IDEA ONE

West Side - Big Development

East Side - Big Scoop

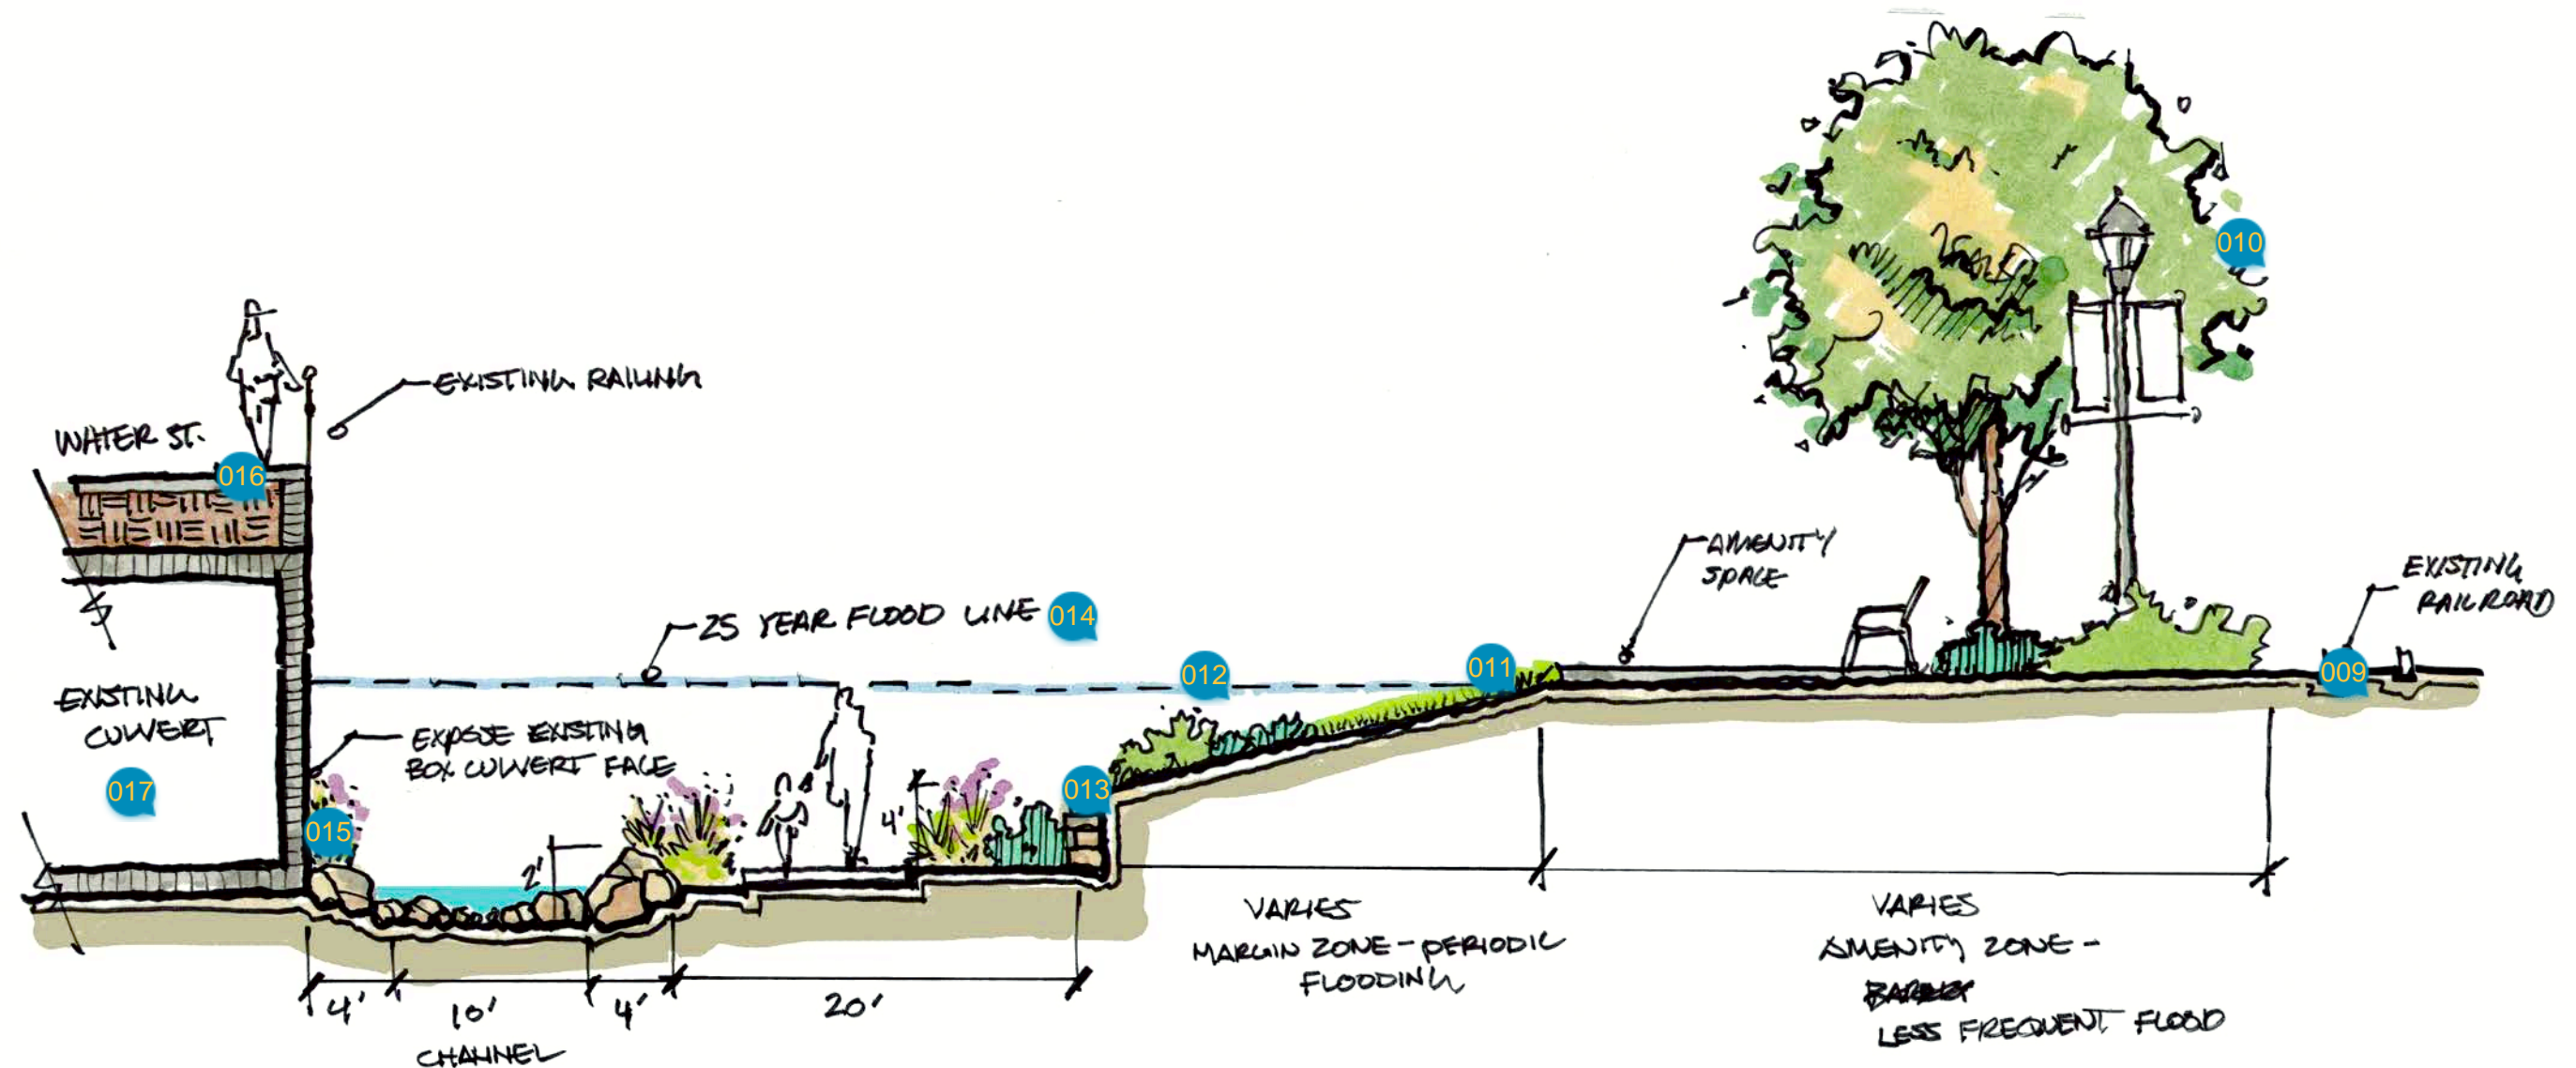
MSU is a really important site factor. With 2000 people there every weekday, they offer the best potential to populate the space when it's not programmed. The spatial relationship between the IDEA Commons (and Brick City in particular) can't be overemphasized.

Skateboarders & cyclists also sometimes congregate in these lots, how can the space serve these existing informal recreational users?

How might this site connect to the West Meadows, and the West Meadows greenway? What might that mean for the site plan within the project?

Having a pedestrian walkway under Campbell is absolutely key. Otherwise the spaces would feel quite isolated.

Saving and embracing the old arch would be fantastic.

Mature trees & rocky bluffs here, consider how this green/natural backdrop can frame use of the space. I've done a lot of clean up in this space in the past... consider how proximity of meandering path might encourage or discourage undesired use. <https://www.google.com/maps/@37.2108838,-93.2942299,3a,60y,226.37h,87.59t/data=!3m6!1e1!3m4!1se9wRrETrH5KeSLVZuuRt1Q!2e0!7i16384!8i8192>

"7"? Brownfield?

Where would the 100-year flood line be? How do the plans for the Meeks site and the upstream regional detention basin plans impact this line (and the 25-year line)?

this walkway is wider, no? More like 7', room for two pairs of pedestrians to pass? Show at scale to emphasize existing walkability of this overlook path.

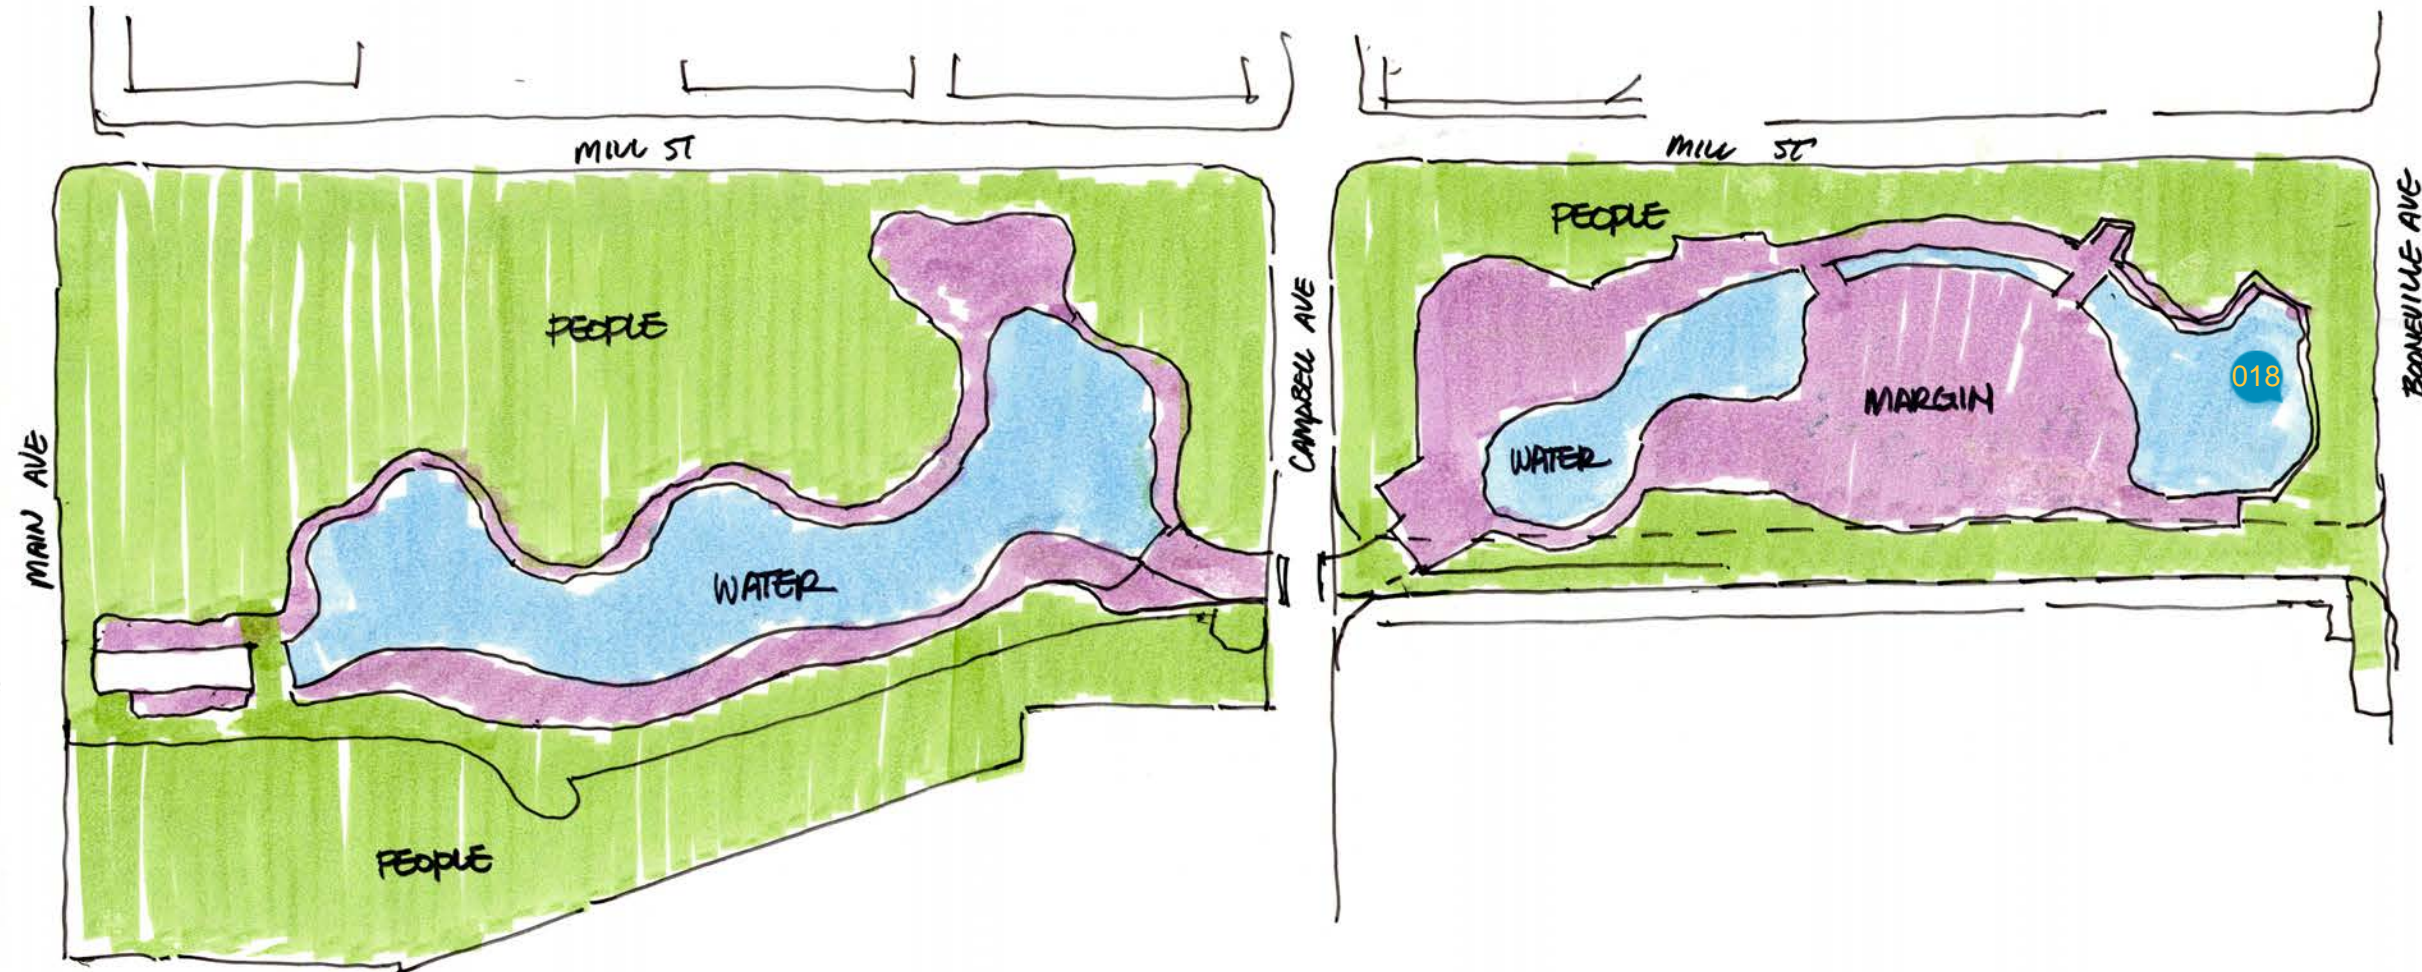
Water too wide - needs to flow

I like this concept of removing the box culverts and maximizing the space here and the idea for Water St. as a pedestrian promenade.

Is the placement of (presumably private) buildings on this public site in response to a sense that the site is too big for open space? Or what?

Regardless of which option is chosen, I believe there will need to be an additional bridge built at Campbell Ave. (north of the stone arch bridge) to meet the flood reduction goals for the project.

Preserving and restoring this stone arch bridge could really be an iconic piece for this area and would preserve some of the history.

Like the culvert gone but water too wide - will be stagnant.

I don't feel creating a lake is an appropriate use of Jordan Creek in this area.

This parking has a GREAT VIEW of the site! Is that the best use of this part of the site?

I get how the "lakes" could be attractive to the developments but they are not very approachable. Plus they attract trash, stale/stagnant water and geese! =)

I would prefer to not see new development in this lower area which will likely remain in the floodplain. Maybe an alternative location for this development could be immediately south of Water St. overlooking this area.

Yes. And up higher i.e. well above the floodplain. While the development itself would be elevated to meet the City's code for developing in the floodplain, it would present another obstacle in the way of floodwaters trying to move through this area.
